Subject: Supplementary Information Associated with the Control Room Emergency Air Treatment System (CREATS) Actuation Instrumentation Change (LCO 3.3.6) Rochester Gas and Electric Corporation R.E. Ginna Nuclear Power Plant Docket No. 50-244

Attachment: R.E. Ginna Nuclear Power Plant CREATS Actuation Instrumentation Design Requirements

**R.E. Ginna Nuclear Power Plant
CREATS Actuation Instrumentation Design Requirements**

CR RADIATION INTAKE MONITORING INSTRUMENTATION (PROPOSED)

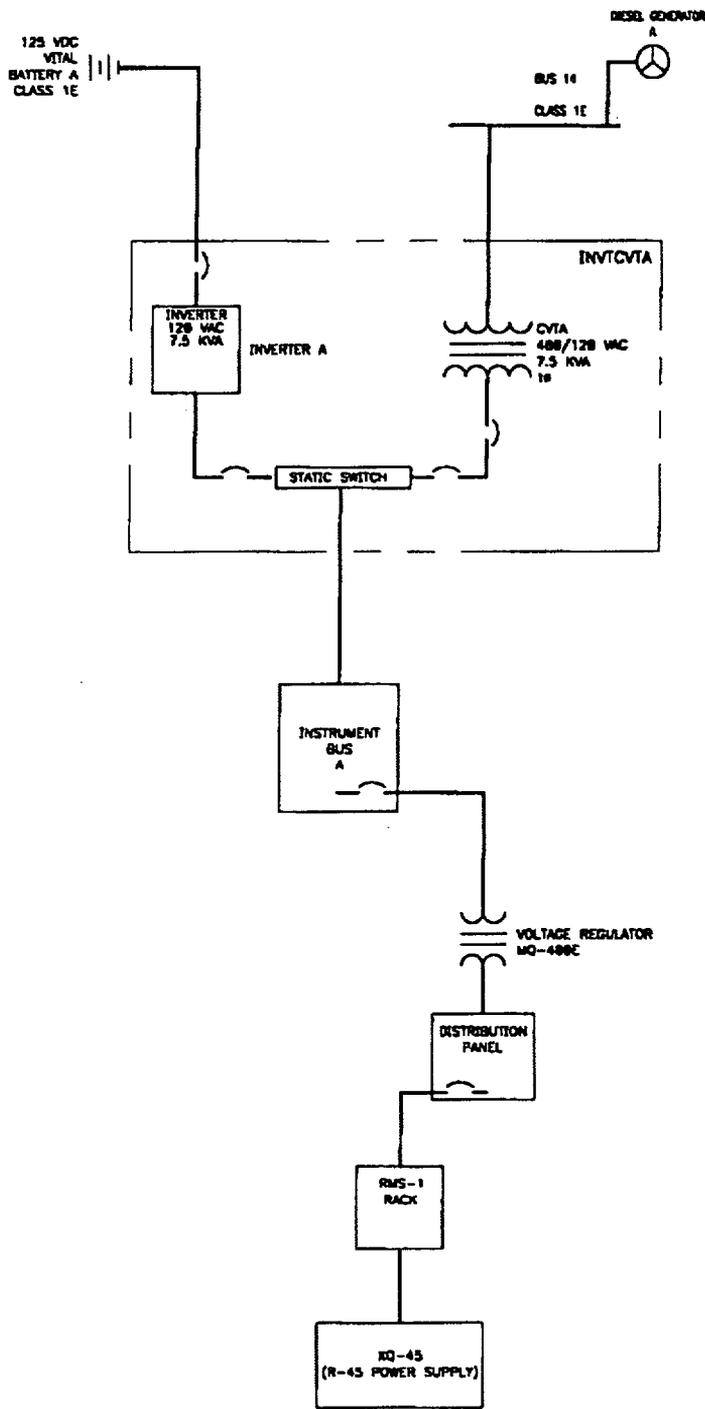
The attached sketch illustrates the redundant logic and the crossovers between the automatic and manual initiation of isolation to ensure that both trains provide an initiation signal in the event that either train receives a high radiation level or manual initiation.

Loss of power to any component (detector, ratemeter, or control relay), will also result in automatic isolation. Redundant Manual Isolation pushbuttons on the Auxiliary Benchboard will initiate isolation in both control logic trains. Additionally, all of the dampers that are used to isolate the Control Room are in a "fail to isolation" configuration.

POWER TO CONTROL ROOM
 RADIATION MONITOR R45 & R46
 ONE-LINE DIAGRAM

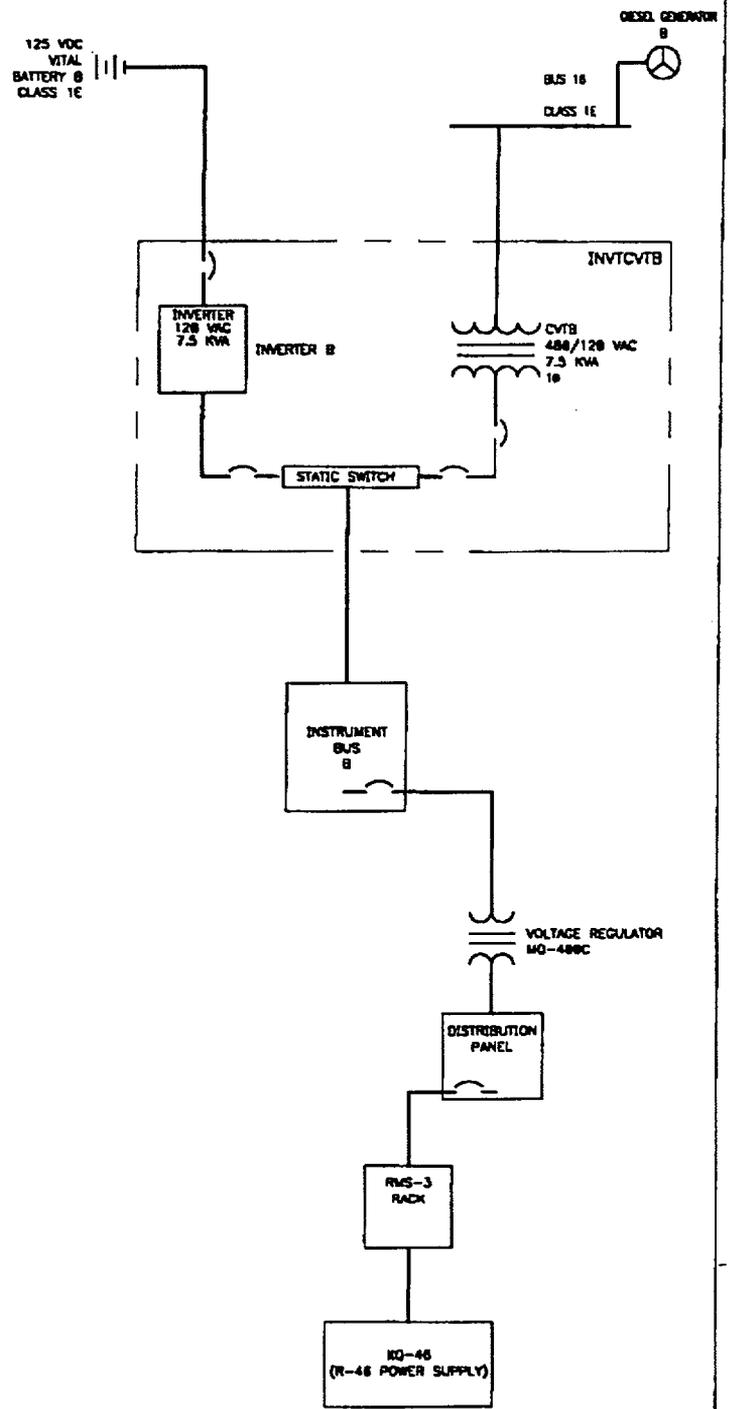
With respect to power train separation, attached is a one-line diagram that illustrates that the power for the two new radiation monitoring systems is fed by independent Class 1E power trains, via our 120 VAC Instrument Power system. Normally supplied by the inverters fed from station DC systems, the system will switch to AC supply with diesel generator backup if required. The Class 1E power trains are addressed in the Ginna Technical Specifications (LCO 3.8.7 and 3.8.9)
